NW Business Park

06-20 New Windsor Business Pk.
Rt. 300 (Dewey St) (Addition)
(4-2-16.4)

TOWN OF NEW WINDSOR
PLANNING BOARD
REVIEW COMMENTS

PROJECT NAME: NEW WINDSOR BUSINESS PARK SITE PLAN AMENDMENT
(NEW YORK LIFE FACILITY)
PROJECT LOCATION: TEMPLE HILL ROAD (NYS ROUTE 300)
SECTION 4 – BLOCK 2 – LOT 16.4
PROJECT NUMBER: 06-20
DATE: 28 JUNE 2006
DESCRIPTION: THE APPLICATION PROPOSES A 6106 S.F. ADDITION TO THE
EXISTING FACILITY ON ROUTE 300. THE PLAN WAS PREVIOUSLY
REVIEWED AT THE 24 MAY 2006 PLANNING BOARD MEETING.

Project No: 06007.000	Date: 4/13/06	Scale: 1"=30'
File Name: SP1-06007	Design By: KAD	DRAWING NO: SP-1
Checked By: KAD	Drafted By: DEC	Sheet 3 of 8

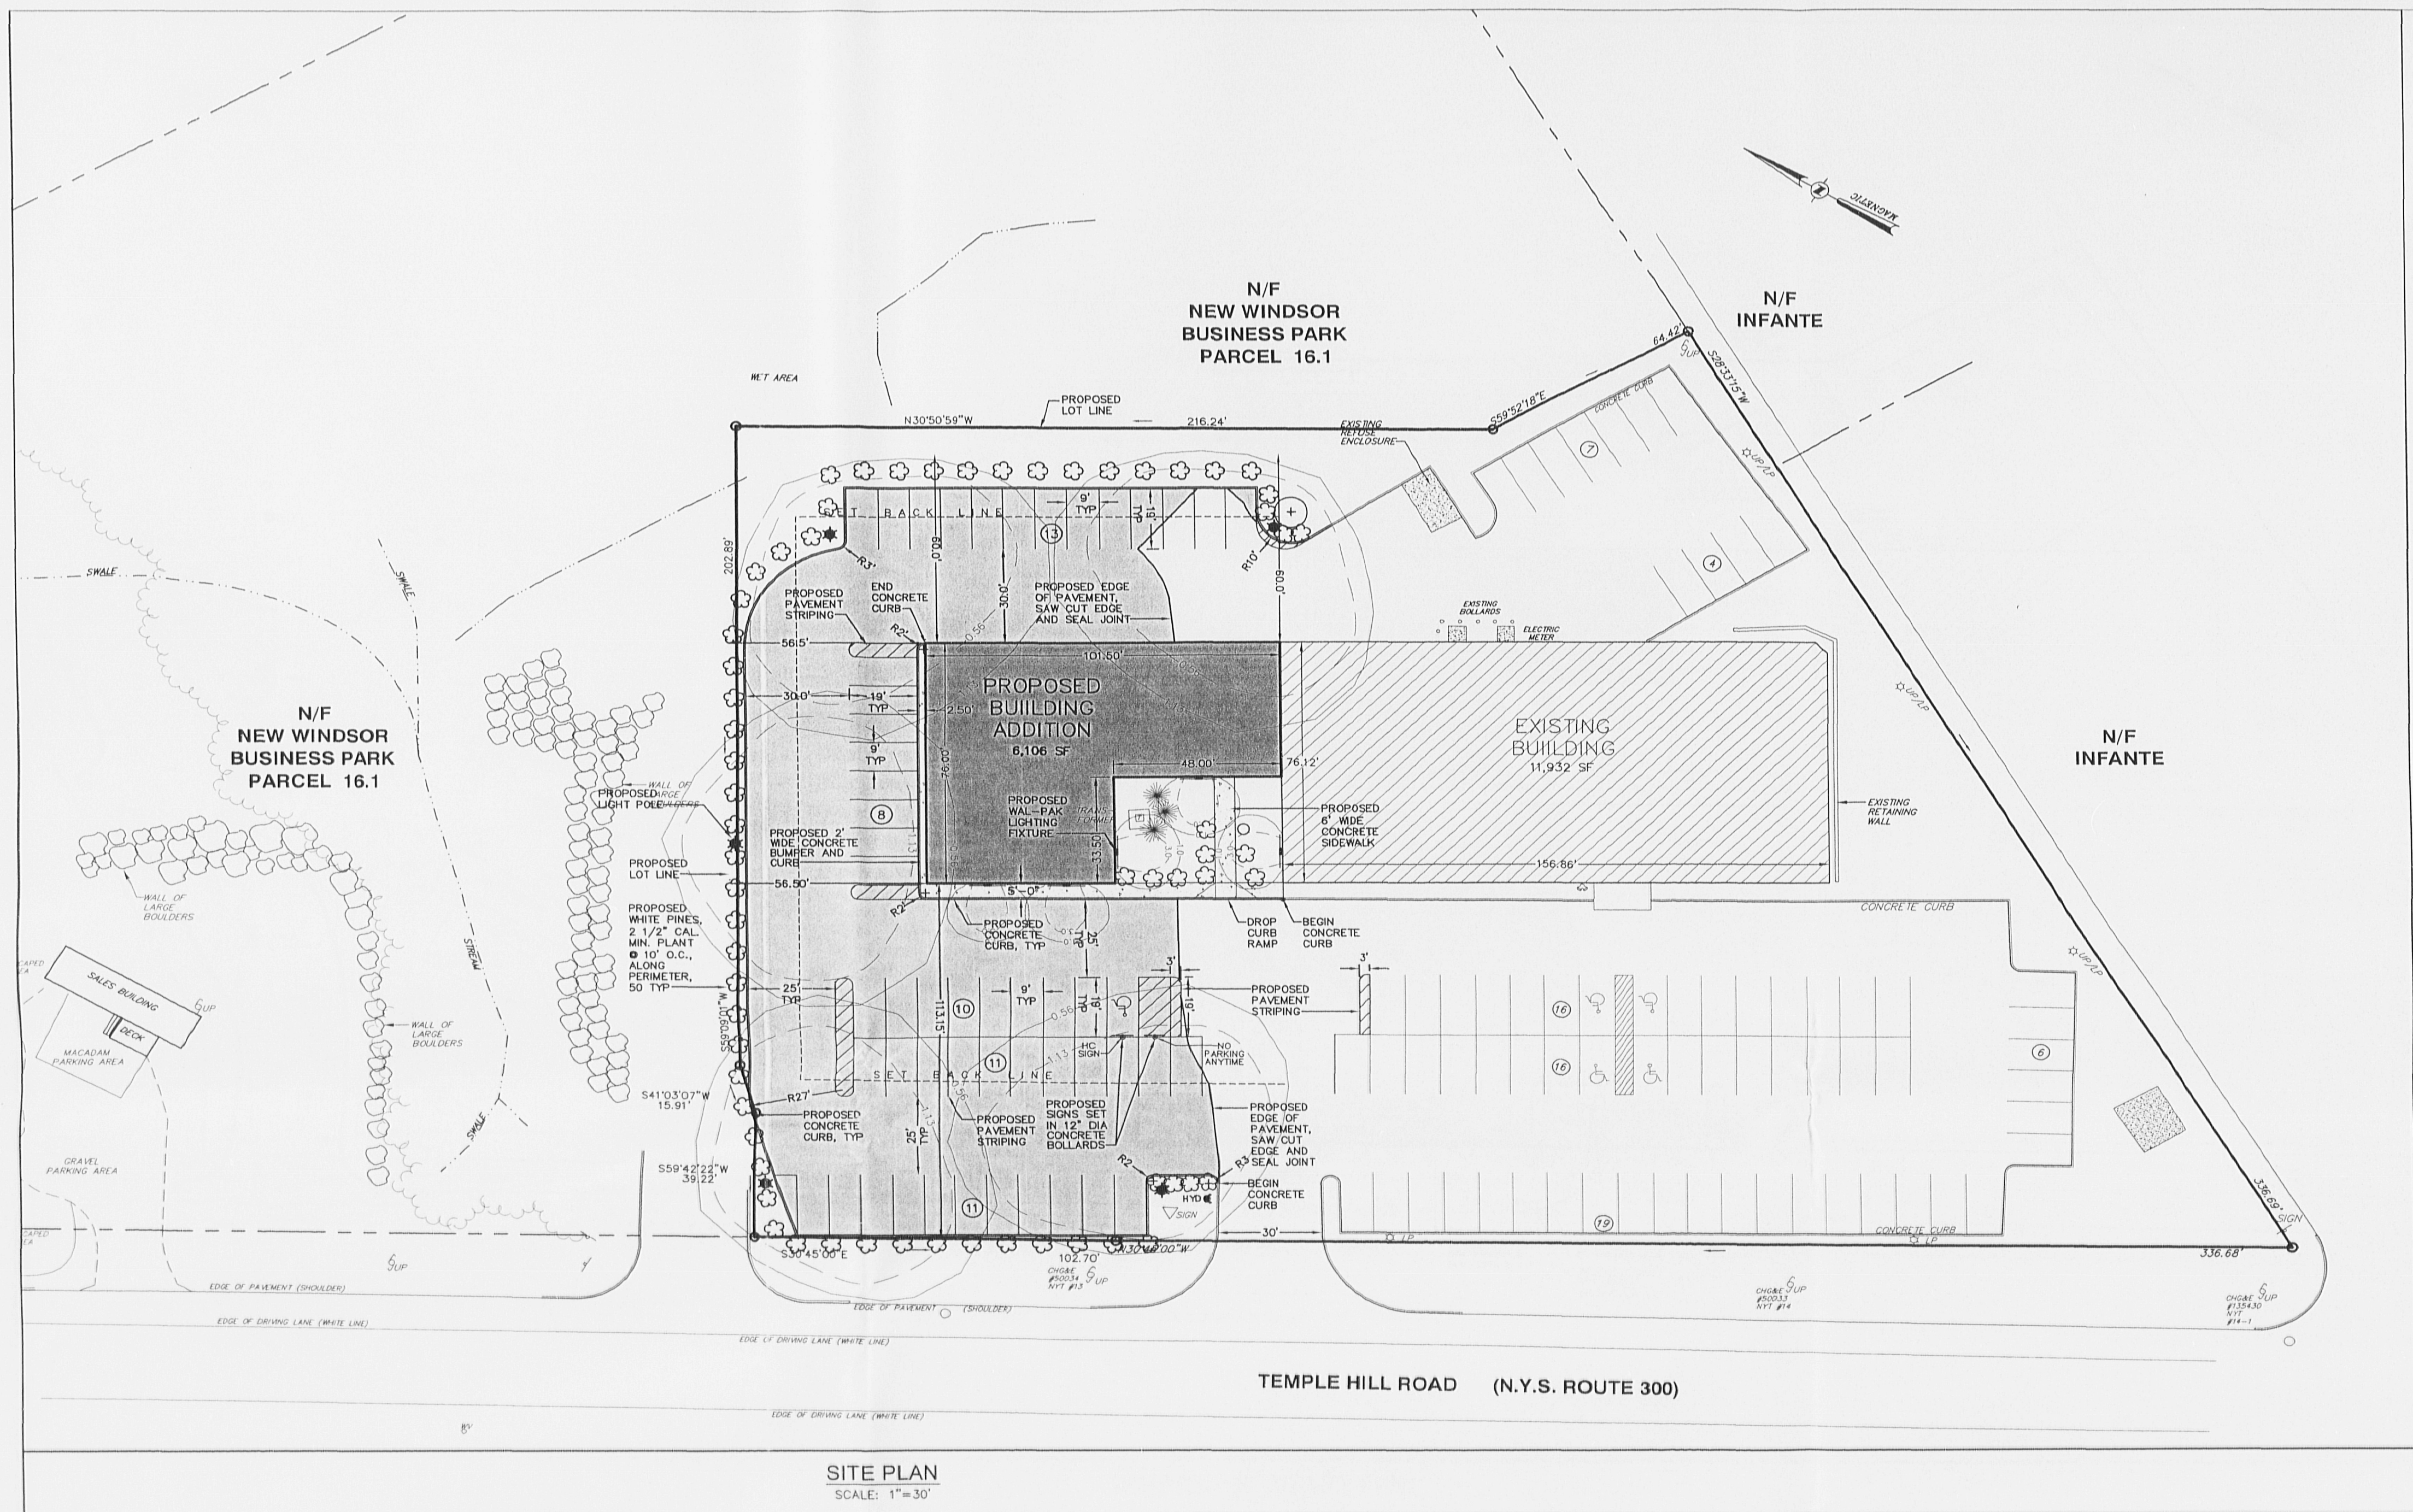
1. The project is in the PI zoning district of the Town. The bulk requirements shown on sheet SP-1 appear correct for the zone and use, with all values in compliance with Town standards.

2. I have reviewed the plans with the Fire Inspector at the recent worksession. The plan predates some current dimensional access requirements. In an effort to improve access, the following revisions have been requested by the Fire Inspector (a copy of his review may be on file by the meeting):

- The building sprinkler system should operate off a single Siamese connection, the location of which should be shown on the plan.
3. I have reviewed the plan for other site plan issues and have the following comments:

- The plan parking calculation applies the new parking requirements to the old (existing) building. Since a change in use is not proposed (the same use is continuing with an addition expanding the use), only the new addition requires the 1 space per 150 s.f. requirement, the old portion of the building can be computed using the parking rate for which it was previously approved. This calculation correction will insure that the removal of the spaces requested by the Fire Inspector will not cause the need for a parking variance.

- The site plan does not include the metes and bounds for the parcel, as depicted on the associated lot line plan. These metes and bounds for the combined parcel should be added, and a note referencing the licensed surveyor (source of survey) should be provided.

- That the plan parking calculation be revised, and metes and bounds with survey note added, as noted by the Planning Board Engineer.
 - That the applicant shall submit a revised plan to the office of the Fire Inspector for approval of the revisions requested.
